Subject: Safety Recall B0A – **Remedy Parts Available**  
Certain 2004 – 2006 model year Highlander/Highlander HV  
Driver's Side Floor Carpet Cover and Retention Clips

**TECHNICAL INSTRUCTIONS**

**SAFETY RECALL B0A**

**FLOOR CARPET COVER**

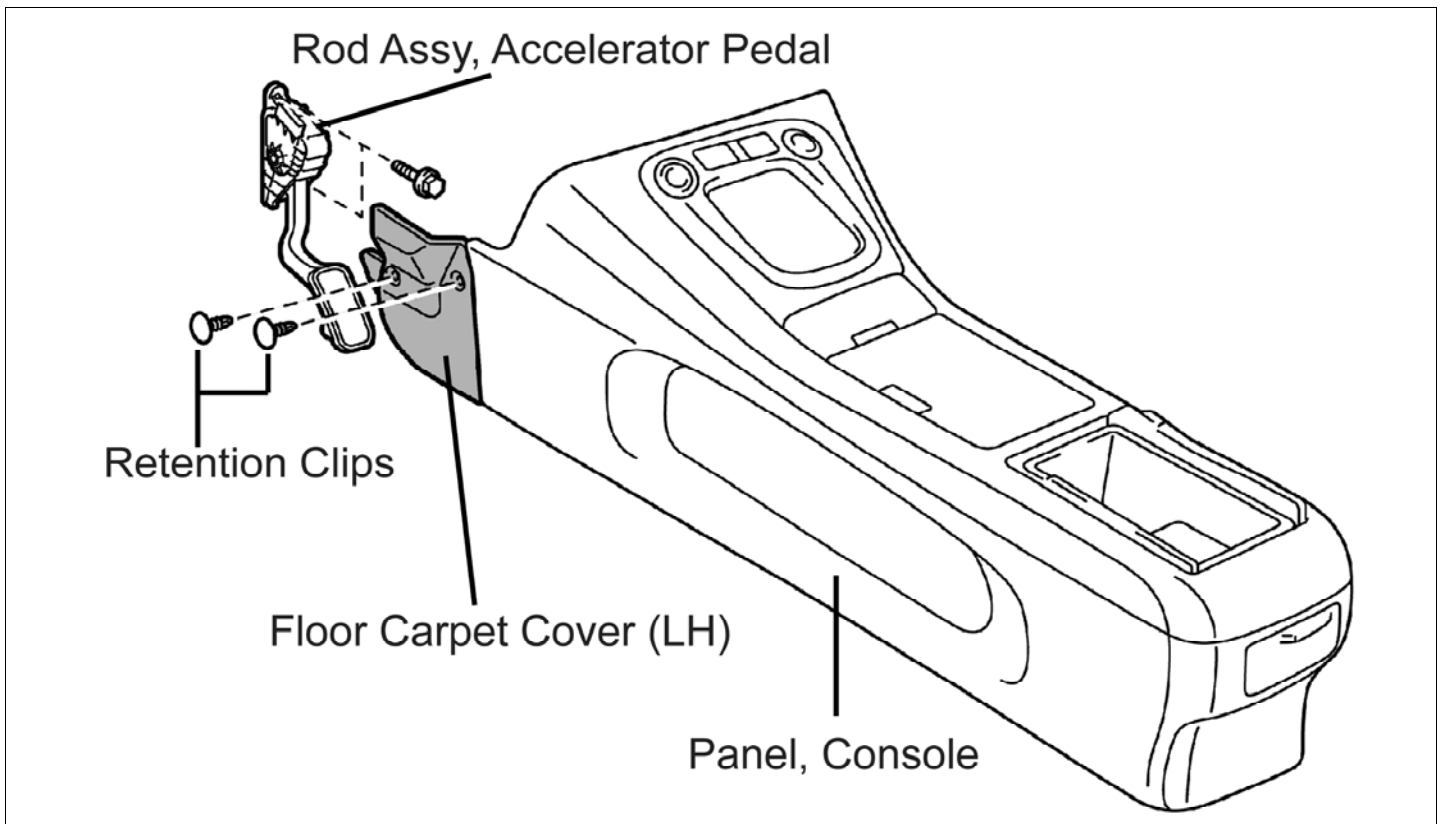
Toyota will replace the Driver's side Floor Carpet Cover and Retention clips with newly designed parts. The new Floor Carpet Cover has an additional tab which extends beyond the travel of the accelerator pedal arm, so as not to interrupt the movement of accelerator pedal arm even if the cover is leaning.

Part Number	Part Description	Quantity
04001-1340E (Ivory)	Cover Kit, Floor Carpet, CTR LH*	1
04001-11348 (Gray)	Cover Kit, Floor Carpet, CTR LH*	1
*The kit above includes the following parts:		
58534-xxxxx-xx	Floor Carpet Cover	1
90467-06020-C0	Retention Clip	2

### 2. REMOVE THE CARPET COVER CLIPS

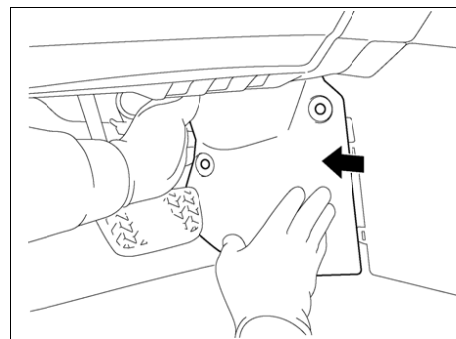
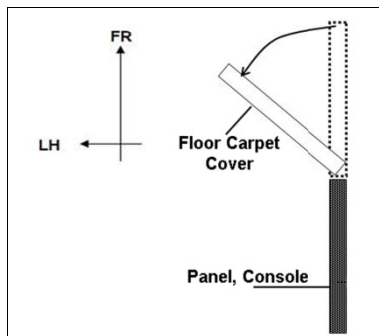
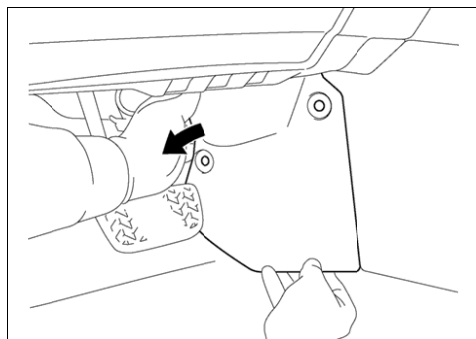
- Remove the two retention clips.

### 5. REINSTALL THE NEW CARPET COVER AND TWO NEW CLIPS
